# City of Alexandria, Virginia

## MEMORANDUM

**SUBJECT:** CONCEPT REVIEW OF 806 NORTH COLUMBUS STREET  
BAR CASE # 2025-00373

# BAR CONCEPT 2

Figure 1: Comparison of previous and proposed configuration of southern townhouse

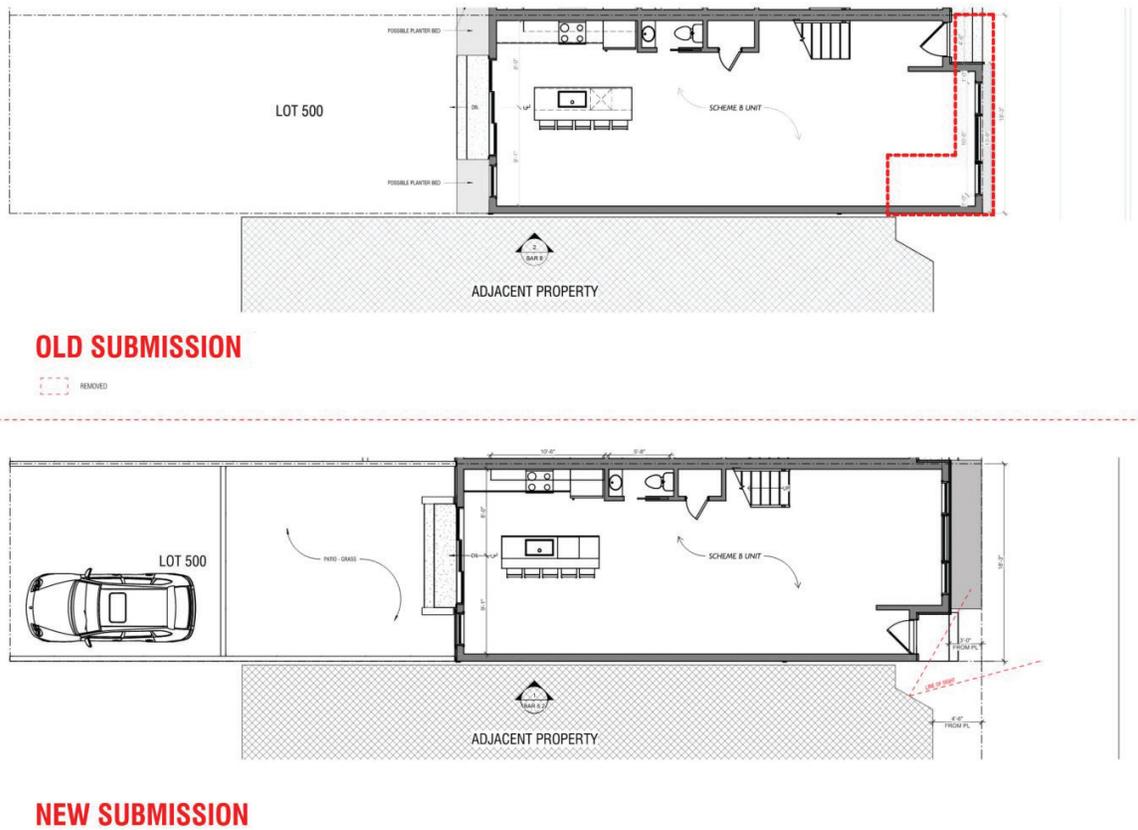
In the previous submission the front of the proposed townhouses was located at the east property line, aligned with the back edge of the sidewalk. During the Concept Review, there was a discussion regarding how the proposed townhouse would affect the existing structure to the south of the project site. This building is located approximately 4'-0" from the east property line and features a three sided bay on the northern section of the east elevation. The proposed townhouses include a rectangular bay with a recessed entry door. In the previous submission, the southern townhouse was situated with the bay on the south side and the recessed entry on the north side. Combined with the location of the building in front of the existing structure to the south, there was concern that this configuration overwhelmed the bay on the existing building.

In the revised submission, the applicant has made two revisions to address this concern regarding the relationship of the proposed townhouses to the existing building to the south (Figure 1). First, the townhouses have been moved back from the east property line by 3'-0". This places it approximately 1'-0" in front of the existing building instead of the previous 4'-0". Second, the proposed southern townhouse has been mirrored to place the bay on the north side of the lot and the recessed entry on the south side, adjacent to the bay on the existing building to the south of the site. The effect of this is that the front wall of the new townhouse immediately adjacent to the south property line is behind the front of the bay on the existing townhouse. This opens up the view of the existing three sided bay from the street and reduces the overall impact of the proposed townhouses on the existing historic building.

1 PROPOSED SITE PLAN  
1" = 10'-0"

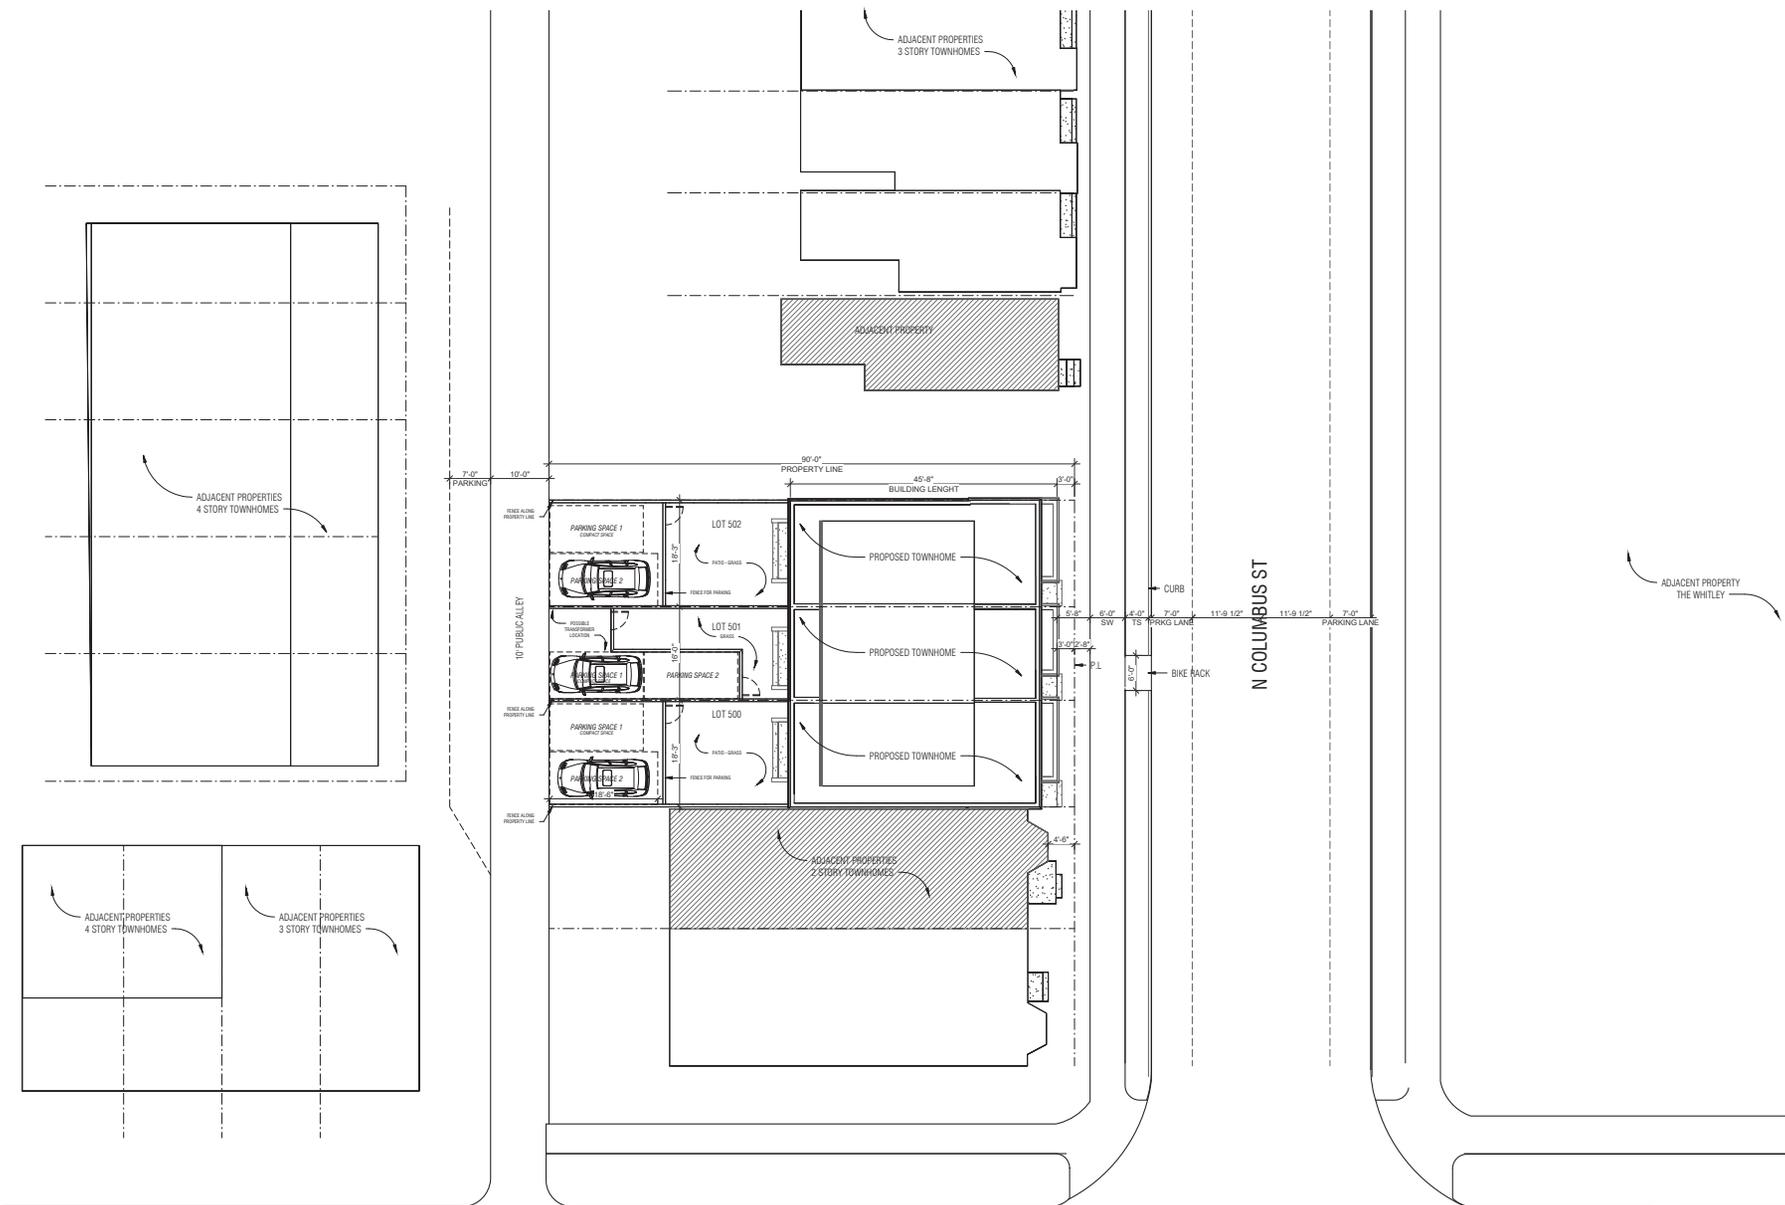
C-3 Proposed lots show parking not in compliance with Sec. 7-1005:  
- Parking cannot exceed 50% of any required yard.

SHEET NAME  
**FENCE DETAILS**

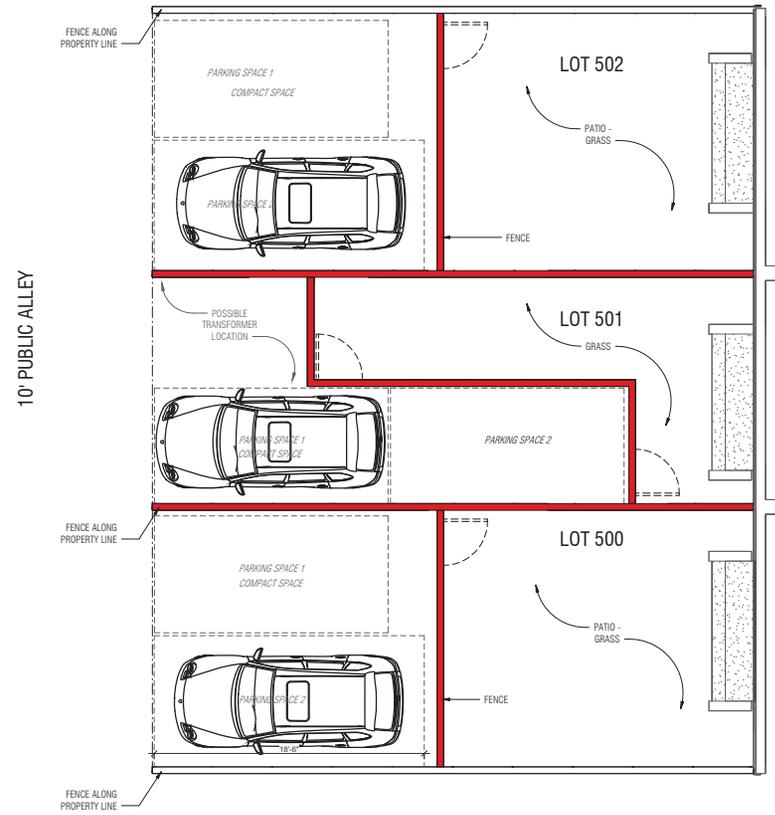
The last submission did not contain much detail regarding the enclosure of the rear yards and how the parking areas are to be configured. Questions about this came up from members of the public and the Board. To address these questions the applicant is now showing a site plan and rear elevation of the proposed townhouses that depict the horizontal wood fence that will be enclosing the rear yards (Figure 3).
